Title - Sujet CCGS Griffon -VLE	
Solicitation No. - N° de l'invitation F7049-200157/A	Amendment No. - N° modif. 024
Client Reference No. - N° de référence du client F7049-200157	Date 2023-08-14
GETS Reference No. - N° de référence de SEAG PW-\$\$MD-029-29039	
File No. - N° de dossier 029md.F7049-200157	CCC No./N° CCC - FMS No./N° VME
Solicitation Closes - L'invitation prend fin at - à 02:00 PM Eastern Daylight Saving Time EDT on - le 2023-10-11 Heure Avancée de l'Est HAE	
F.O.B. - F.A.B.	
Plant-Usine: <input type="checkbox"/> Destination: <input type="checkbox"/> Other-Autre: <input type="checkbox"/>	
Address Enquiries to: - Adresser toutes questions à: Jeddi, Loubna	Buyer Id - Id de l'acheteur 029md
Telephone No. - N° de téléphone (873) 455-3835 ()	FAX No. - N° de FAX (819) -
Destination - of Goods, Services, and Construction: Destination - des biens, services et construction:

Solicitation Amendment # 024

1. To include Questions and the Responses for the solicitation.
2. To update SOW item 12.16 Rudder and Steering Gear REV.01 section B.1.8 (English Version only).

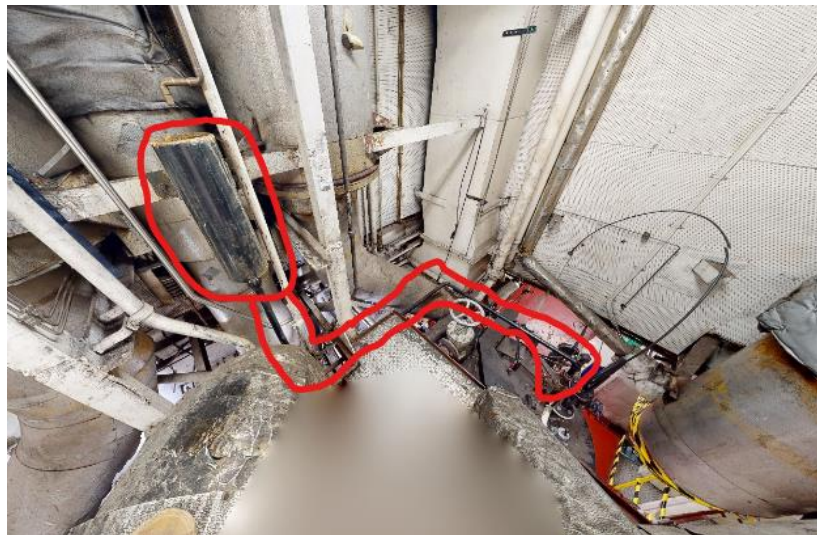
Q#2: SOW item 16.13

Does the "bâche" in the French specification or "hot well" in the English specification quoted in C.2.4 d) correspond to the "condensate tank" in drawing 664-4203-2?

A#2: The "hot well" refers to the condensate tank located in drawing 521-353-001s1. See attached photo of condensate tank, feed pumps and check valves (starboard boiler in background of photo).
